COMMUNITY BOARD FEEDBACK PACKAGE

DINING OUT NYC

Business Name: Rancho Tequileria

Application Number: 20240802010266

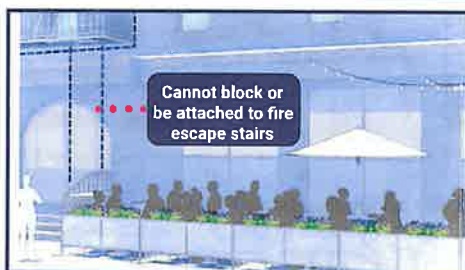
Comments related to the cafe's **physical footprint and dimensions**:
The proposed sidewalk cafe site plan does not allow the required 10' clear path between the fire hydrant/bollards and the cafe perimeter (when measured accurately). The proposed site plan also does not allow the required 10' clear path between the pedestrian ramp on the corner of 9th Avenue and W.50th Street and the cafe perimeter. To remedy these issues, the applicant has agreed to remove 2 tables with 2 seats each, leaving the cafe with 2 tables and a total of 4 seats. The applicant has prepared the attached Revised Site Plan reflecting these changes.

REVISED PLANS

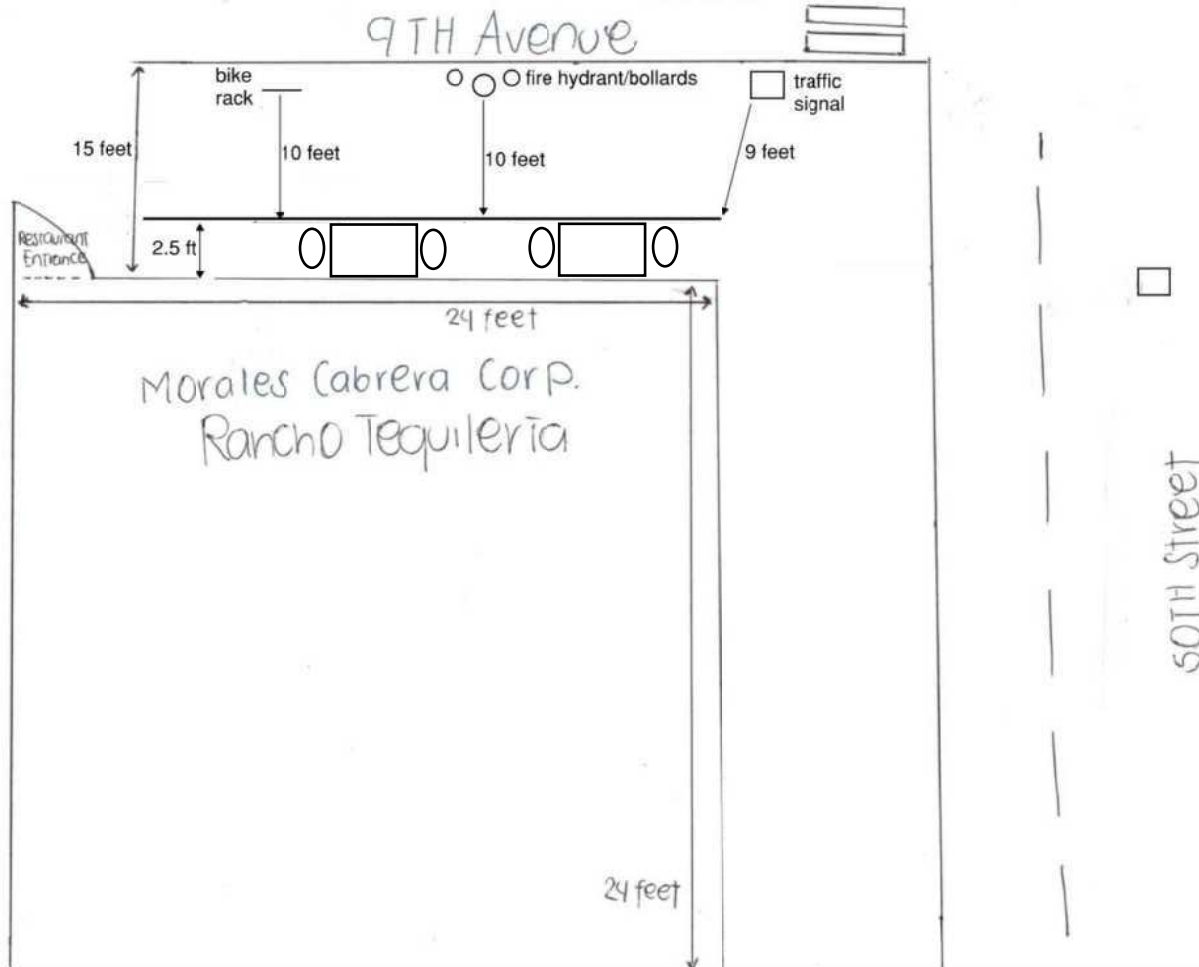
☒ Community Board recommends **approval w/ modifications**
Recommended modifications (**only if approved w/ modifications**):
The proposed sidewalk cafe site plan does not allow the required 10' clear path between the fire hydrant/bollards and the cafe perimeter (when measured accurately). The proposed site plan also does not allow the required 10' clear path between the pedestrian ramp on the corner of 9th Avenue and W.50th Street and the cafe perimeter. To remedy these issues, the applicant has agreed to remove 2 tables with 2 seats each, leaving the cafe with 2 tables and a total of 4 seats. The applicant has prepared the attached Revised Site Plan reflecting these changes.

☒ Applicant acknowledges and agrees to modifications relating to the above referenced application
